## SERVICE BULLETIN NO:00007

**MODELS : TX-DS989**

**SUBJECT : The sound of fan is large.**

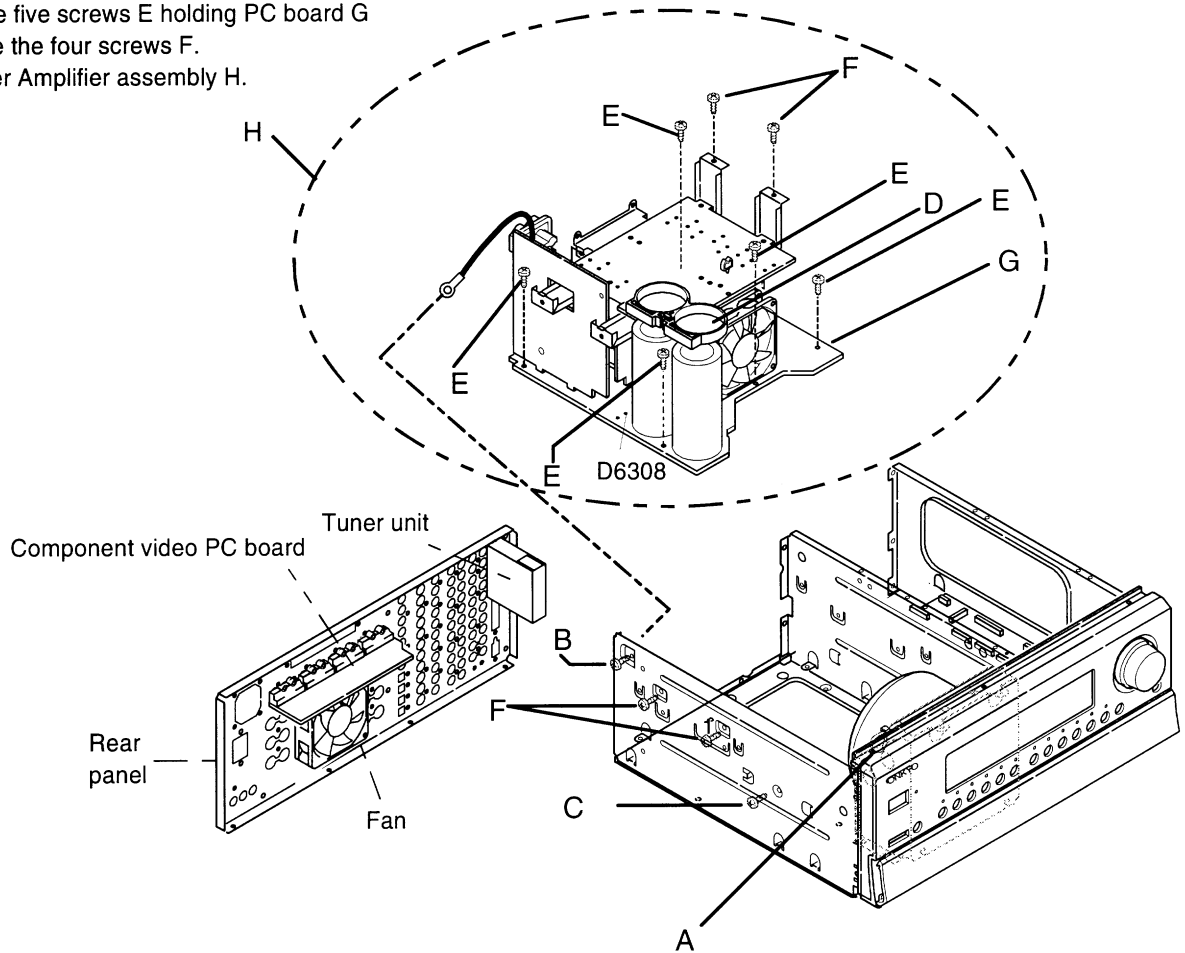
**Counter-measure:** The drive voltage of the fan is decreased from 13V to 10V so that the operation sound when rotating is decreased.

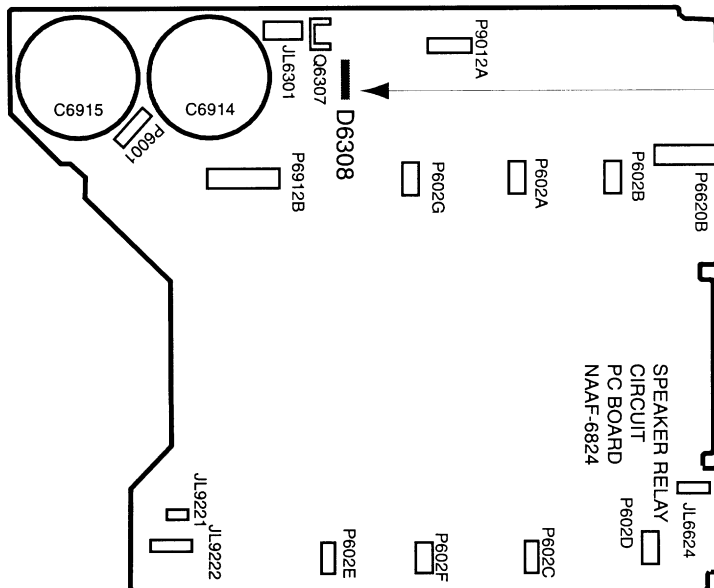
Replace the zener diode D6308 to MTZJ10C on the PC board below.

Change the zener diode to MTZJ10C.  
(Part No.224471003)
